Re: SSD 10436 – Response to Request for Additional Information (RFI)

To: Steve Foster
From: Mark Irish
Date: 12 March 2021
Subject: Horsley Logistics Park
NVIA Addendum Report - Collated Response to DPIE RFIs

At: ESR
At: SLR Consulting Australia Pty Ltd
Ref: 610.19360-M06-v0.1 NVIA Addendum
Collated.docx

Figure 1 Lot 201 Vehicle Source Locations – Access Road and Loading Area

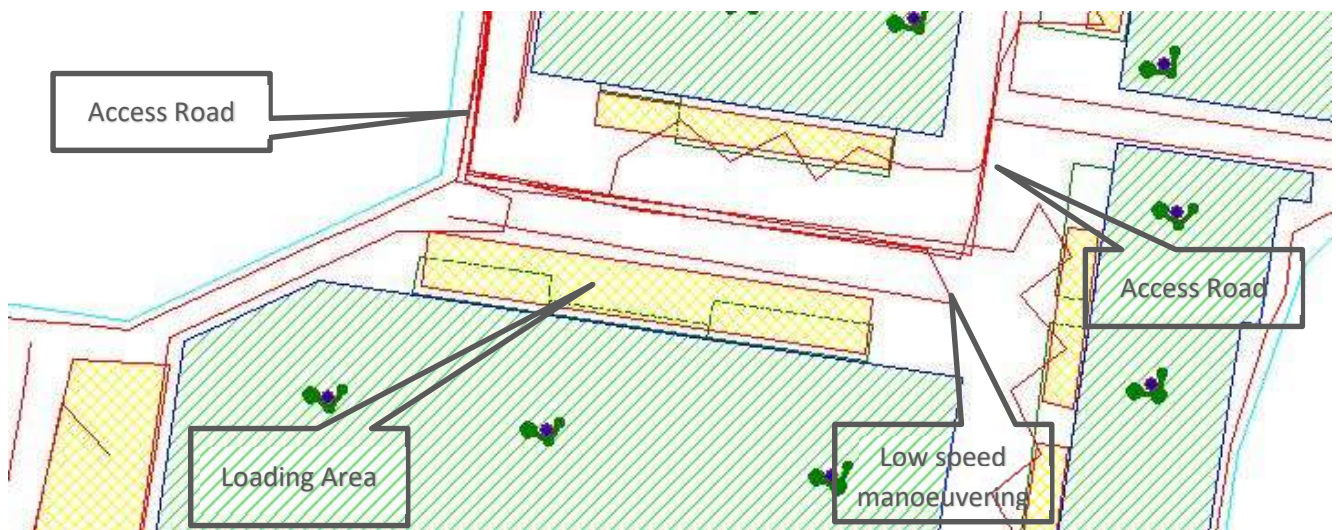
Loading docks are anticipated to be utilised by 19 metre semi-trailers for reversing movements and super B-double for side-loading. However, there is no evidence that all heavy vehicle manoeuvres identified in the transport assessment have been taken into account in the operational noise assessment.

The NVIA must be revised to incorporate each distinct outdoor operation corresponding to side-loading as well as heavy vehicles idling, passing by, accelerating and reversing (including the contribution of energy-average noise emission associated with non-tonal reversing alarms). This would involve changes to modelled sound power levels for onsite vehicle movements and source path footprint. In addition, the representative duration of noise emission for each distinct operation also need to be amended accordingly. It should be noted that it is unlikely articulated trucks and B-doubles would be able to manoeuvre safely at 25 km/h when turning and reversing on site.

A sensitivity analysis has been conducted to confirm whether the current modelling assumptions include sufficient allowance for the increased sound power levels associated with low speed activities in the loading and hardstand areas.

The relevant locations for the vehicle movement path (using Lot 201 as an example) are shown in **Figure 1** below.

The source SWLs in **Table 4** indicate the SWL associated with each of the vehicle manoeuvring and loading scenarios. Lot 201 night-time peak has been used as an example but the same principle would be applicable to each Lot within the estate.

The source contributions in **Table 4** indicate that the existing modelling assumption provides a reasonable estimate of the overall sound power level to account for a variety of different vehicle speeds and reversing alarm activity. The only scenario which anticipates a slightly higher SWL (a negligible 1 dB increase) is Scenario 4 with a 25 km/h speed limit on all access roads, together with reversing alarms operating for 30 seconds per vehicle on average.

Figure 2 NCA 01 Receiver Location

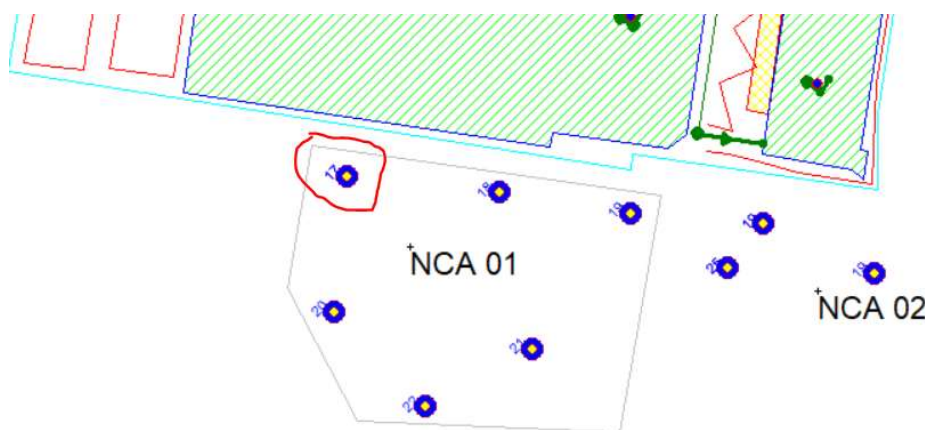
Given the NVIA reported exceedances of sleep disturbance screening criterion at all residential assessment locations and that the predicted temporal variation in noise is well above 5 dB within a 15-minute assessment period, the Department considers the application of a +5 dB modifying correction for intermittent noise to be warranted.

To assess whether the reversing alarms are likely to be dominant in a peak scenario, the following source contributions are provided for one example receiver in each of NCA 01 (Table 6) and NCA 02 (Table 7). These are the most significant noise sources at this location which contribute to the overall ambient noise level. The predicted noise levels are for night-time, weather enhancing conditions as this is the controlling time period for the assessment.

The results above indicate that the noise contribution from any individual reversing alarm is around 6 dB or more below the overall receiver noise level. Whilst reversing alarms are significant in terms of noise contributions, when considered in the context of other noise sources operating across the site and the overall LAeq receiver level they would not be considered individually dominant.

Figure 4 Lot 204 Loading Area – Extended Canopy Wall

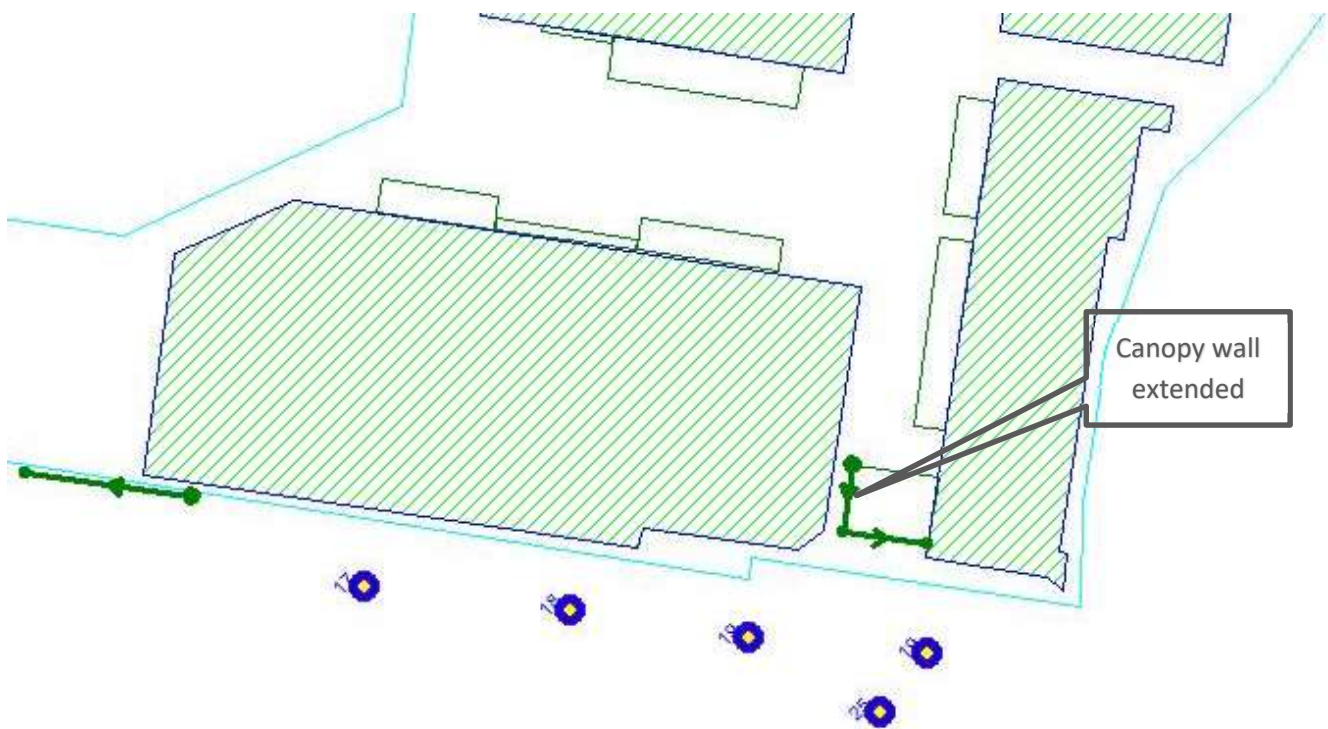
However, a scenario has been identified where a reversing alarm operating on the southern Lot 204 loading area could be considered intermittent at the nearest receiver in NCA 02.

Additional attenuation of a reversing alarm with the Lot 204 loading area has been investigated by means of an extension to the canopy wall (to eave height) as indicated in **Figure 4** below.

Individual reversing alarms in Lot 204 were re-modelled with the results included in **Table 13**.

In this mitigated scenario it is predicted that a 5 dB intermittency correction would no longer be applicable in the night-time peak or Lot 201 and 204 reduced activity scenario as indicated in **Table 14**.

Figure 6 Modelled Noise Mitigation Measures and Representative Receiver Locations

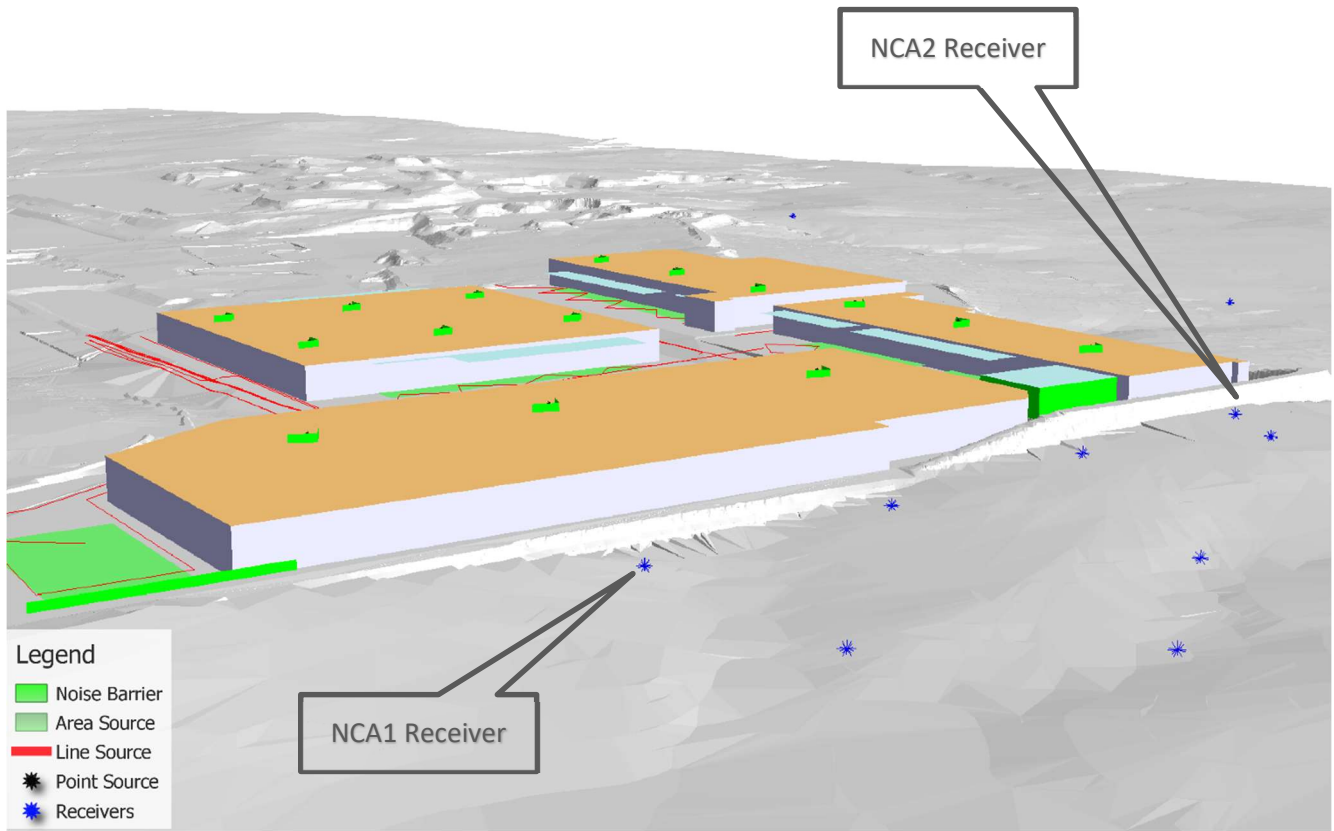
Further to the above, the application of modifying corrections for annoying noise characteristics need to be evaluated and implemented in line with the guidance from the EPA and WHO. According to the Noise Policy for Industry, noise levels measured or predicted at a receiver attracts a +5 dB(A) penalty correction if the noise heard at the receiver varies by more than 5 dB(A) and the intermittent nature of the noise is clearly audible. Guidelines for Community Noise from the World Health Organization (WHO) reiterated the need to account for the intermittent character of noise when setting night-time noise limits in terms of L_{Aeq} noise levels. The WHO notes that the intermittency of a time-varying sound can be determined by quantifying the number of noise events as well as examining the difference between the maximum noise level and background noise level.

L_{A90} background noise level by definition is the level exceeded for 90 percent of the measurement period and represents a level that is almost always there in between intermittent noise events. Only “201(2) condenser” from Table 4 of the addendum NIA has the potential to affect the background noise level as all other sources generates non-steady noise. However, a steady noise level of 22 dB(A) from noise source “201(2) condenser” at NCA 02 Receiver is unlikely to affect the measured rating background level. Thus, the Department maintains the position stated in the RFI dated 19 January 2021 that a +5 dB modifying correction for intermittent noise is warranted. This RFI requested the application of the intermittency correction on the basis that the NVIA reported exceedances of the sleep disturbance screening criterion at all residential assessment locations and that the predicted temporal variation in noise would therefore be well above 5 dB(A) within a 15-minute assessment period. A detailed maximum noise level event assessment is required to justify the exclusion of the intermittency correction for the mitigated scenario presented in Table 11 of the addendum NVIA. The Department would deem the exclusion of the intermittency correction appropriate at the EIS stage if the level exceeded for 10 percent of the assessment period of 15-minute is predicted to be less than 5 dB(A) above the rating background noise level. The detailed assessment should consider all feasible and reasonable noise mitigation measures with a goal of achieving the $L_{Aeq,15minute}$ and L_{Amax} trigger levels.

The noise mitigation measures included in the model are shown in **Figure 6** and briefly summarised below:

- 3 m noise barrier to southern boundary of Lot 201 hardstand
- Infill noise wall to Southern and Western eave height of Lot 204 super canopy
- Rooftop plant screening to Southern and Eastern elevations.

The screening test for the most affected receiver in each noise catchment indicates that the maximum reversing alarm noise level at the receivers would not be considered intermittent with the mitigation measures included in **Figure 6**.
